CHAPTER 3  
INSTALLATION REQUIREMENTS

**Submitted by Robert Rice 1/26/10**  
**Reviewed by subcommittee on 2/11/10 and 2/18/10**

Figure 305.3.3.1.1(1) Installation – Rails perpendicular to framing members

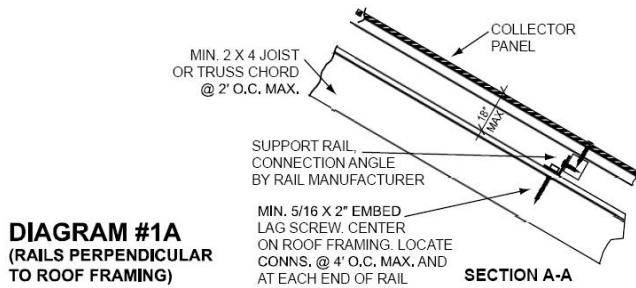
~~3. 3-~~ Loading: ~~Collectors-Modules~~ are either directly attached to the roof framing or are mounted to continuous rails that are attached directly to the roof framing. These attachments must be anchored to roof framing at a spacing no greater than 48 inches (1219 mm) on center maximum in any direction where snow loads do not exceed 25 psf and 24 inches on center maximum in any direction where snow loads exceed 25 psf. Installation shall comply with Figure 305.3.3.1.14(1) or 305.3.3.1.14(2). ~~Maximum load shall not exceed xx pounds (xx kg) of combined dead plus live or snow load at each support.~~ The combined weight of the PV modules and racking shall not exceed 4.5 pounds per square foot (xxx kPa). See Figure 305.3.3.1.14(1).

4. Height: Maximum panel height above roof shall be 18" from top of panel to roof surface and in accordance with Figure 305.3.3.1.1(1). For installations where the panels will not be mounted flush with the roof, a building elevation showing the height of the installation will
